Safety Bulletin

No: SB017 | Rev: 1 | Date: 22 December 2011

Elevator Horn Catch Hazard

Figure 1

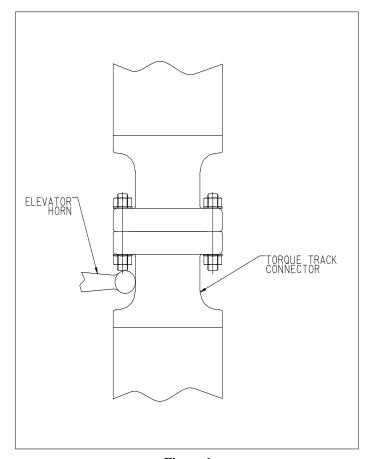
There has been a reported incident where, as the result of an error in top drive operation, the elevator horn(s) became caught in the torque track connector flange cavity. This can cause the lower end of the tubular held by the elevator to move with uncontrolled and unpredictable motion.

This presents an equipment and personnel injury hazard when <u>all</u> of the following listed conditions exist.

- 1. Hoisting or lowering with tubulars latched in elevators and
- 2. Elevators are reversed having the elevator horns facing the torque track and
- 3. Elevator links are tilted toward the torque track.

See Figure 1 to illustrate this condition.

Figure 2: Torque track nuts (fasteners) in a typical installation

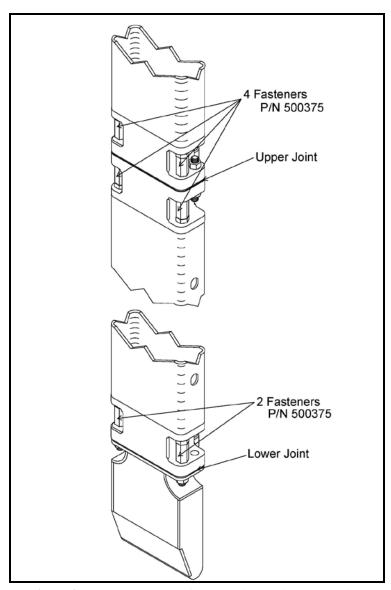
Action Required for 4" x 12" Torque Track (HMI Model Only)

Replace the existing forward facing nuts, at vulnerable flange connection locations, with fasteners P/N 500375 (qty. 4 and 2 for upper and lower joints respectively). This will prevent the elevator horns from entering the torque track connector cavity. Ensure that the nuts are torqued with the flats facing forward. See Figure 2 for a typical configuration.

Figure 3: Torque track, guard installation (well side) and guard latched (mast side)

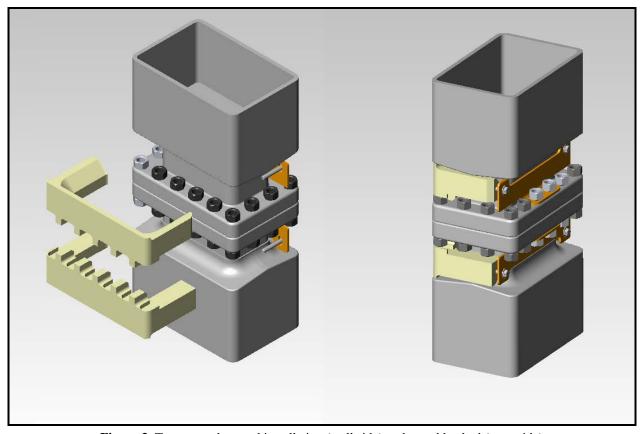
Action Required for 8" x 12" Torque Track (All Other Models)

Obtain and install Insert Kit(s) P/N 720524-1 (qty. 1 per joint) at vulnerable flanged connector locations to prevent the elevator horns from entering the torque track connector cavity. See Figure 3 for a typical configuration.
